NELSON WOODS SUBDIVISION, **RESUBDIVISION OF LOT 2**

APPLICATION NUMBER 5 DATE March 23, 2017

DETAIL SITE PLAN

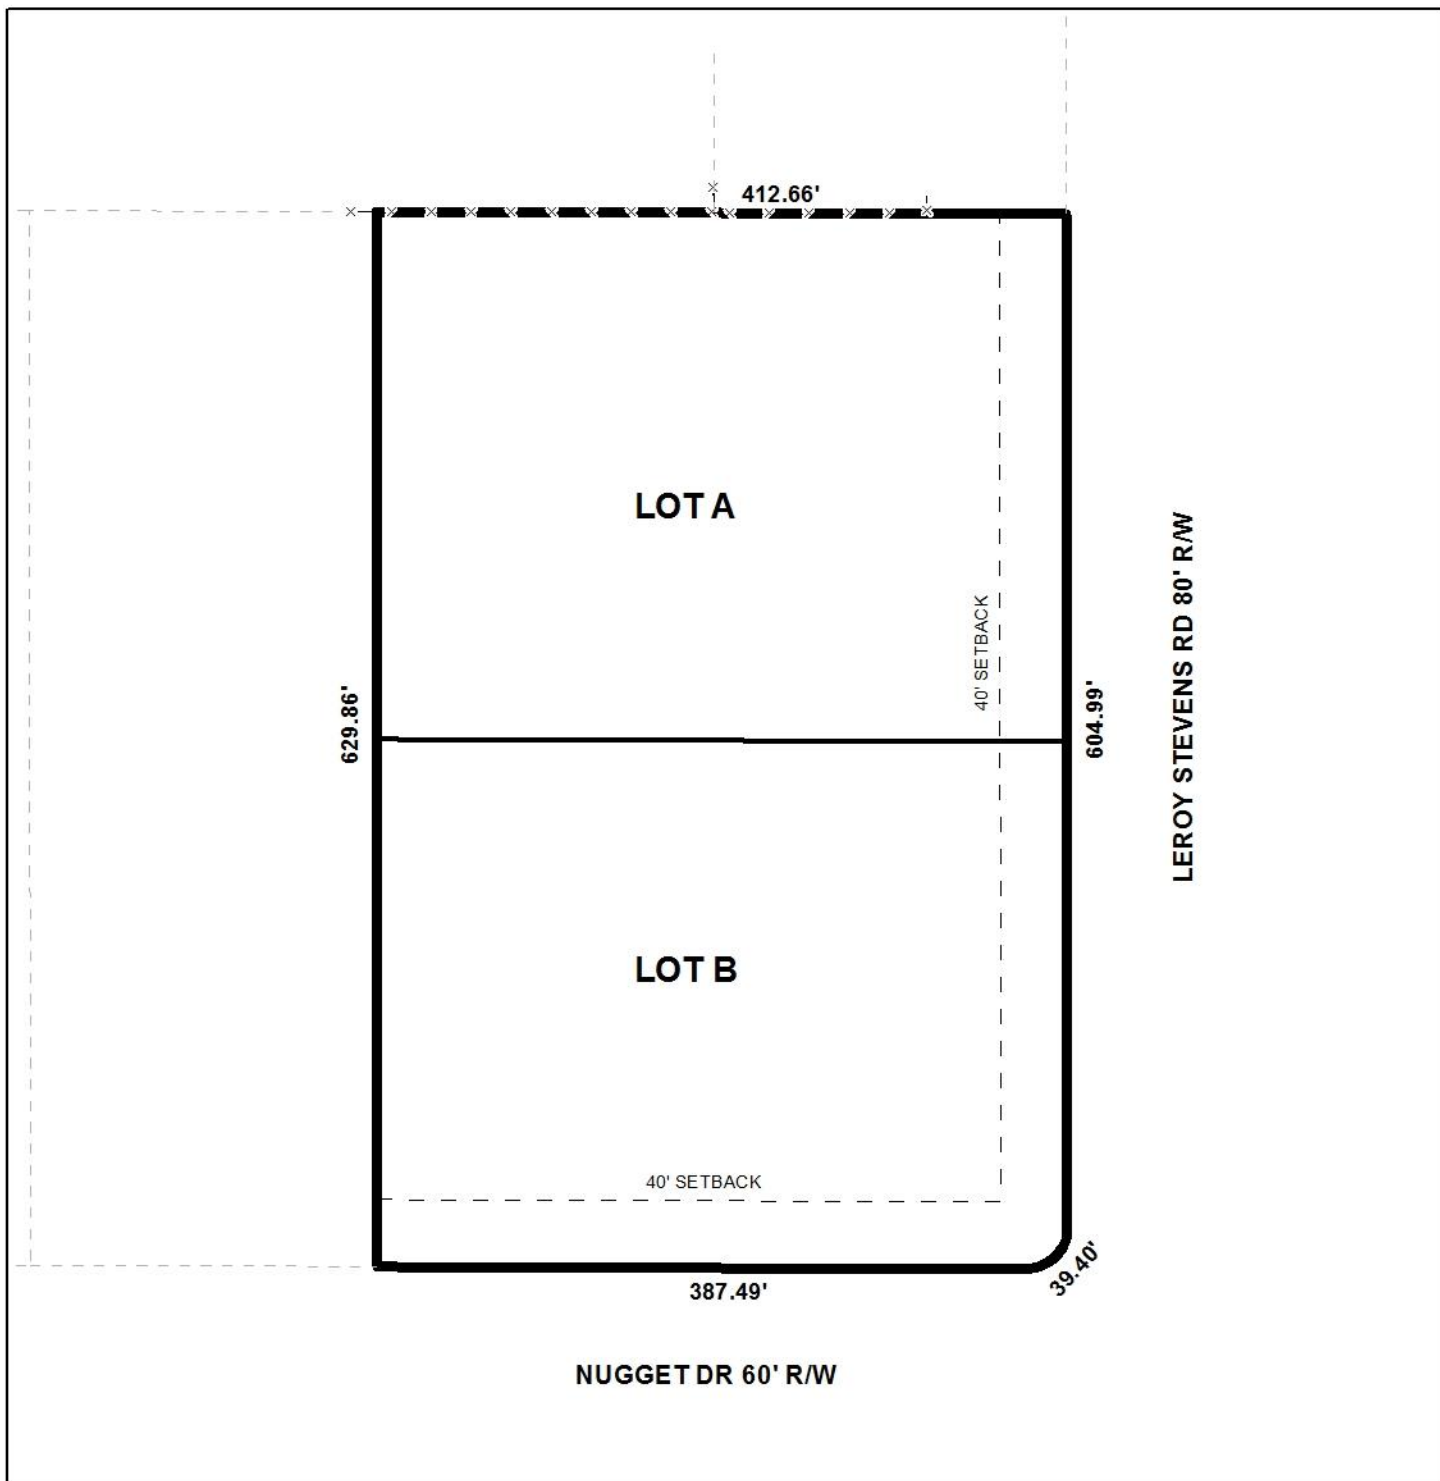
The proposed lots front Leroy Stevens Road and Nugget Drive. Leroy Stevens Road is a minor street that requires a minimum right-of-way width of 60'. The right-of-way width is illustrated as 80' on the preliminary plat, and should be retained on the Final Plat, if approved. Nugget Drive is a paved minor street without curb and gutter, and as such, requires a right-of-way width of 60'. The right-of-way width is illustrated as 60' on the preliminary plat, and should be retained on the Final Plat, if approved.

In accordance with Section V.D.2. of the Subdivision Regulations, the proposed lots exceed the 15,000 square foot minimum lot size requirements for lots served by city water and individual septic systems. The lot size information is depicted in both square feet and in acres on the preliminary plat, and, if approved, should be retained on the Final Plat.

The 40-foot minimum building setback line is depicted on the preliminary plat along both Leroy Stevens Road and Nugget Drive for the proposed Lots A and B. If approved, the 40-foot minimum building setback line should be retained on the Final Plat.

As a means of access management, a note should be placed on the Final Plat, if approved, stating that Lot A is limited to two curb-cuts to Leroy Stevens Road and that Lot B is limited to three curb-cuts, with the size, design, and location of each curb-cut to be approved by Mobile County Engineering and conform to AASHTO standards.

- 1) Retention of the 80' right-of-way width along Leroy Stevens Road;
- 2) Retention of the 60' right-of-way width along Nugget Drive;
- 3) Retention of the lot size information in both square feet and in acres for each proposed lot;

- 4) Retention of the 40' minimum building setback line along Leroy Stevens Road and Nugget Drive for Lots A and B;
- 5) Placement of a note on the Final Plat stating that Lot A is limited to two curb-cuts to Leroy Stevens Road and that Lot B is limited to three curb-cuts, with the size, design, and location of each curb-cut to be approved by Mobile County Engineering and conform to AASHTO standards;
